Sea World Ground Storage Tank Replacement
Solicitation Number: CO-00430-SM
Job No.: 21-6004

ADDENDUM #2
07/27/21

SAN ANTONIO WATER SYSTEM
SEA WORLD TANK REPLACEMENT PROJECT
GST DETAILS
(SHEET 1 OF 8)

SAN ANTONIO WATER SYSTEM
SEA WORLD TANK REPLACEMENT PROJECT
GENERAL DETAILS
(SHEET 3 OF 3)

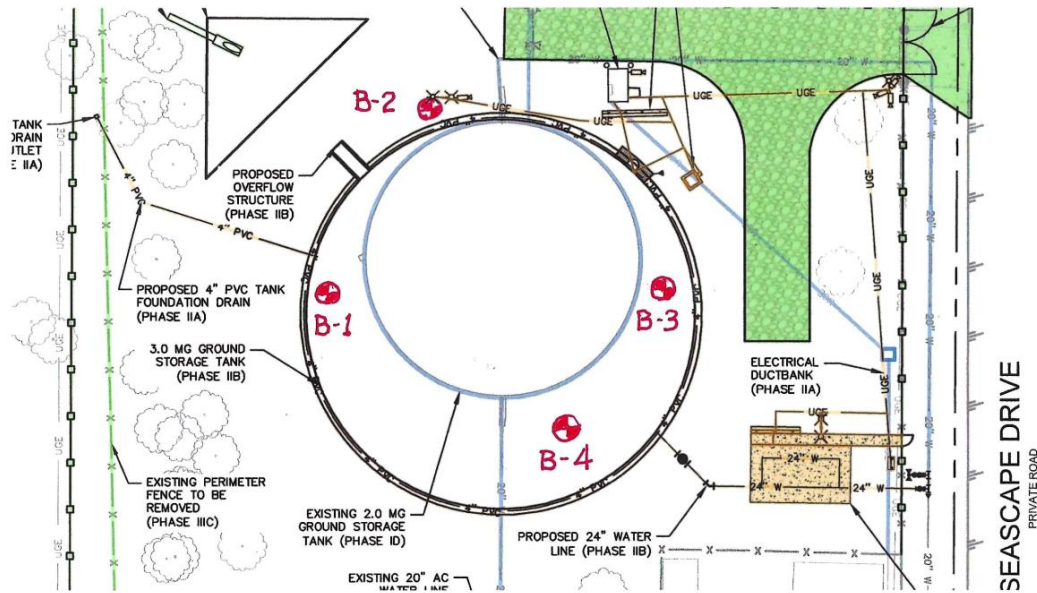
24. As shown in the attached sketch (which is based on the Boring Location Plan on PDF page 12/18 of the geotechnical report), one boring (B-2) lies just outside the proposed tank footprint, but the other three (B-1, B-3 and B-4) lie inside the footprint. While this provides a fairly reliable “picture” of what conditions to expect under nearly 46% of the new tank area, we do not know the conditions under the existing tank – other than the fact that the soil there has been preloaded over the years with a pressure of roughly 3,000 psf by the 47’± high water column. Both the boring logs and the boring log Tables on pages 5 and 6 of the geotechnical report describe Marly Clay with Plasticity Index of 20% to 32% as “Lean”. However, considering that at Boring B-3, and at a depth of only 4’ below grade (elevation 952’±), the soil exhibits a PI = 32 and LL = 49, we respectfully request a confirmation that this condition will not result in PVR movements greater than 1 inch at tank floor level.

Response: Refer to Specification 13205 2.01.F and 2.01.G for Contractor's geotechnical engineering requirements.

SHELL MANWAY DETAIL
SCALE: NTS

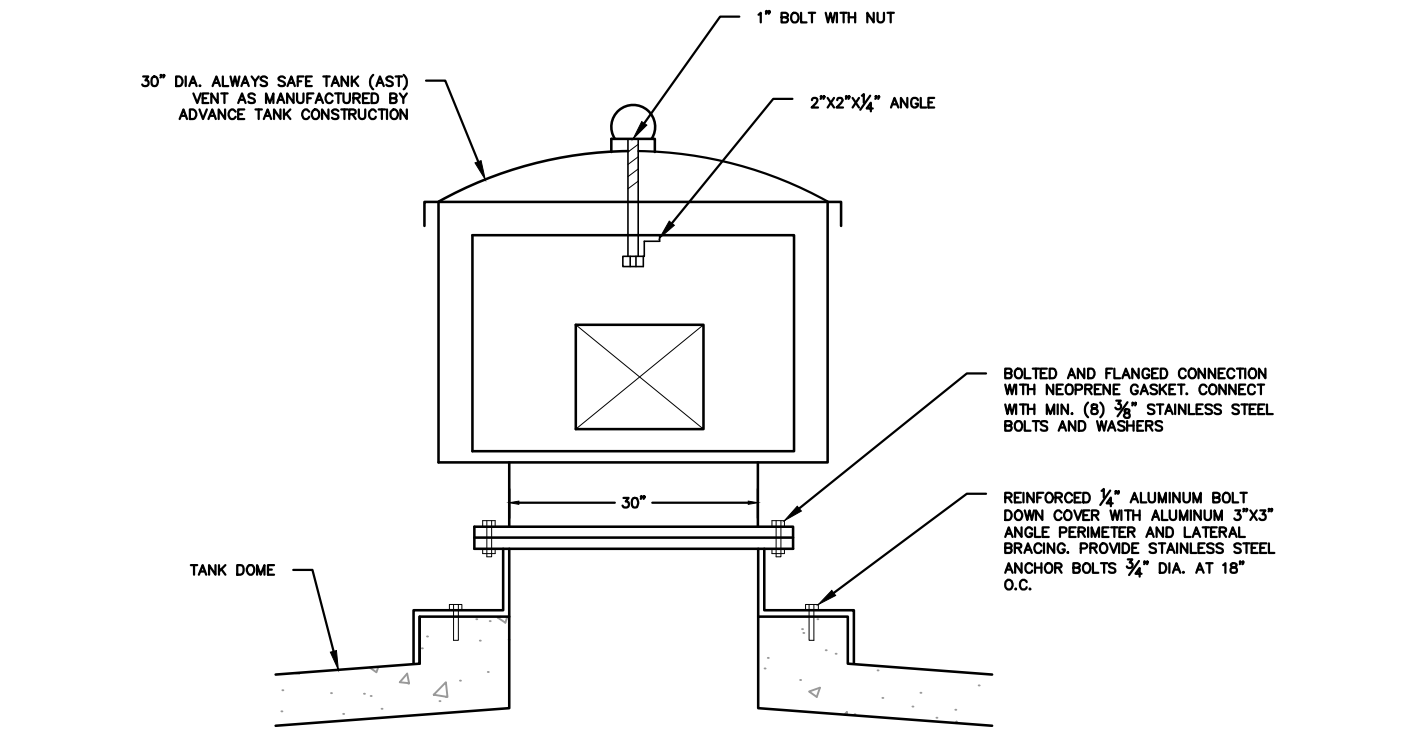
15. Please confirm if a 30" Clear – 37" OD manway is acceptable. Detail 2 on sheet C8 is not standard.

4. Sheet C8 – GST Details (Sheet 1 of 8)

Response: A 36-inch I.D. Manway is required per SAWS Standards. Please refer to Changes to the Plans 4.

REMOVE and REPLACE in its entirety with attached Sheet C8 – GST Details (Sheet 1 of 8).

**TANK FOUNDATION DRAIN LINE PERFORATION
DETAIL**

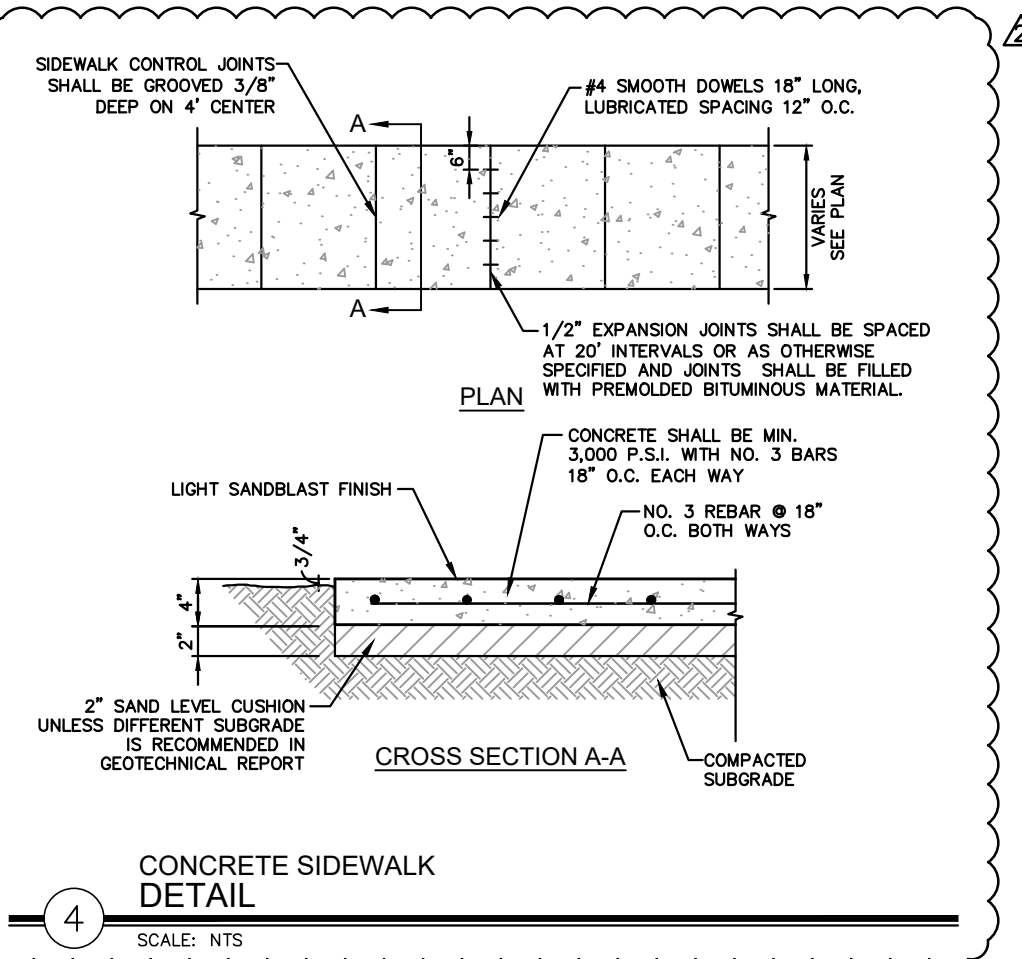
- 28. Ref Plan Page C4 – 4" PVC Tank Foundation Drain Outlet.**
a. **Please provide the required pipe materials for the 4" PVC Pipe.**
b. **Please provide a detail showing the Perforation Pattern for the 4" PVC**

Response: The 4" PVC drain line shall be ASTM D2729 perforated PVC. A detail has been provided for the perforation pattern. Refer to Changes to the Plans 7.

**CONCRETE SIDEWALK
DETAIL**

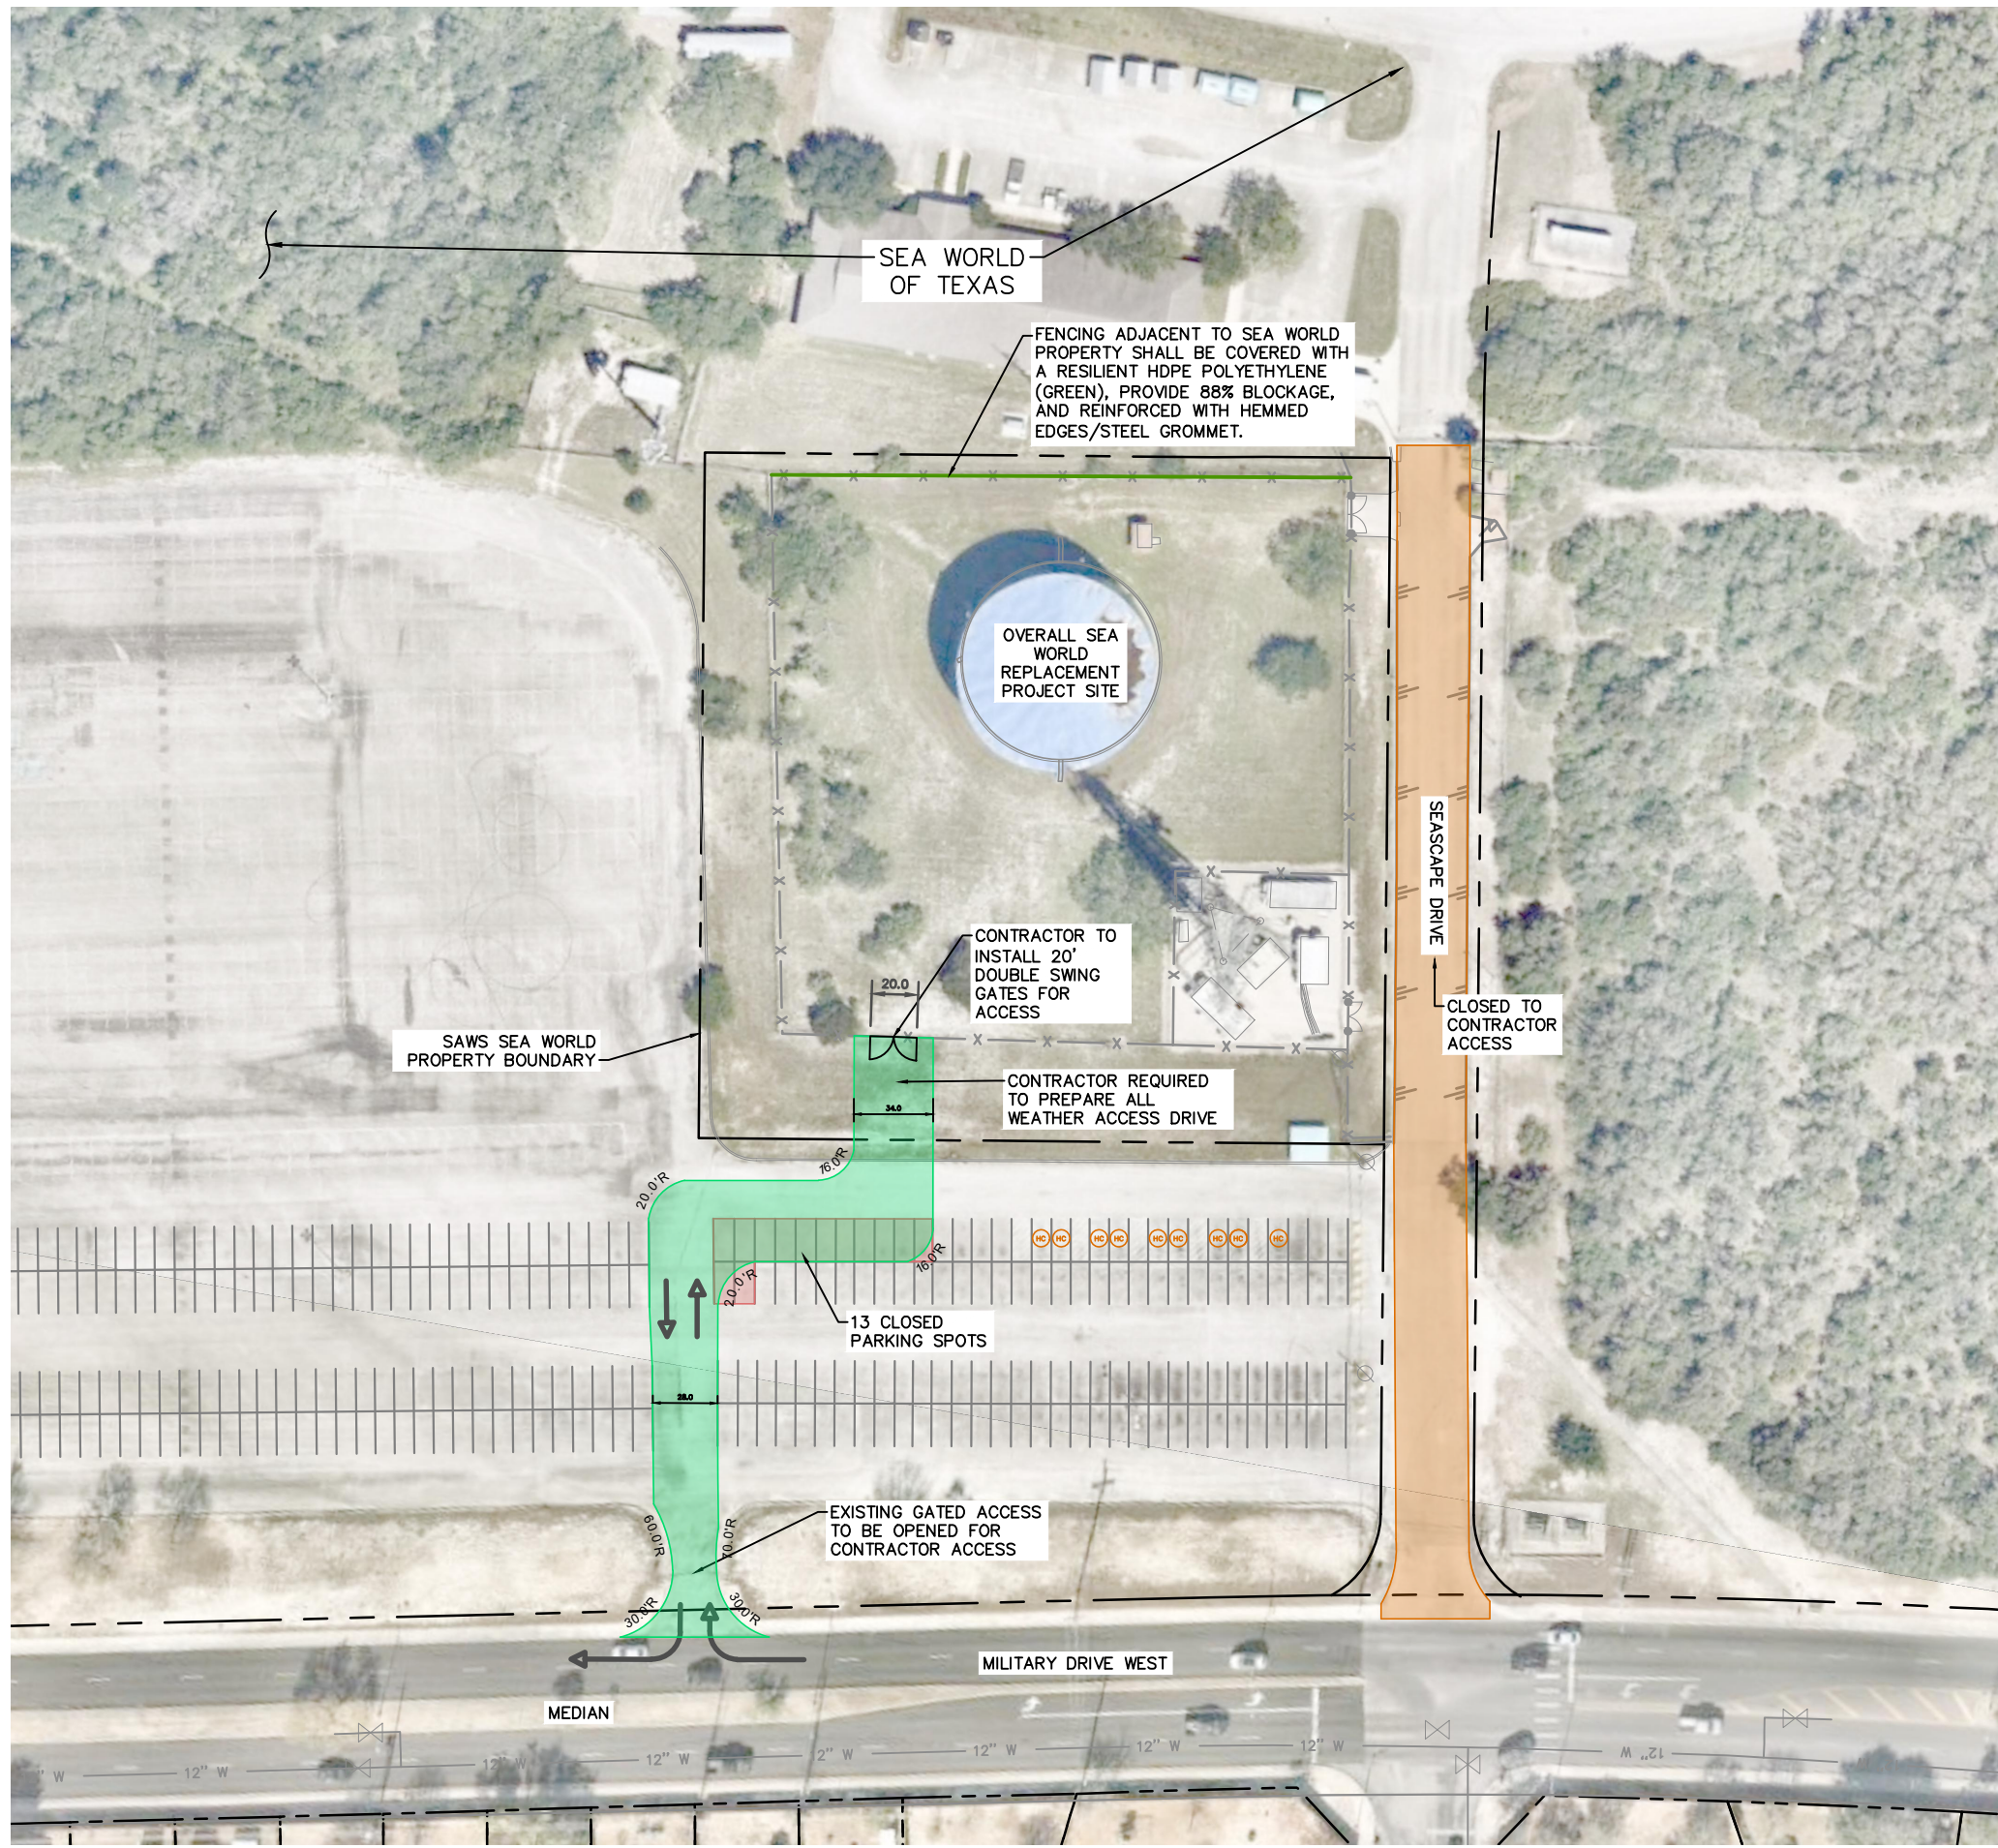
- 38. Sheet C4: Need sidewalk detail for sidewalk adjacent to altitude valve slab.**
Response: On Contract Document sheet C18, a sidewalk detail has been provided. Refer to Changes to the Plans 7.

7. Sheet C18 – General Details (Sheet 3 of 3)

REMOVE and REPLACE in its entirety with attached Sheet C16 – General Details (3 of 3).
